Here are CTC's comments on The Plain roundabout plans. The committee of Cyclox has also reviewed your proposals and fully supports and endorses both CTC's comments and the points made by Oxford Civic Society¹. We are grateful for the way you have kept us informed about the planners' thinking before the formal consultation has gone out. We have felt much more engaged with you in a meaningful way than on many previous projects. That has been a very good part of the process.

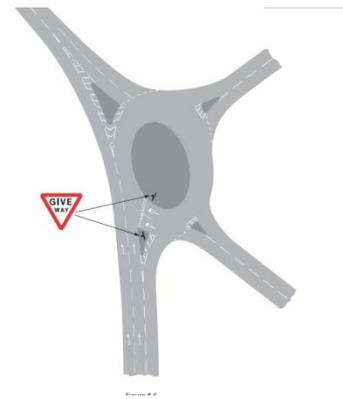
3. We are disappointed that the suggestion of measures to **inhibit speeds of on-roundabout traffic** in conflict with emerging off-bridge cyclists aiming for Cowley/Iffley exits has been rejected without sufficient explanation. What is the flowrate round this section, and how often each day would the capacity of the carriageway to absorb waiting vehicles without blocking bridge-bound traffic be exceeded? (Reproduced at left, for example, is Fig 8.6 of the Traffic Signs Manual, which could apply here:
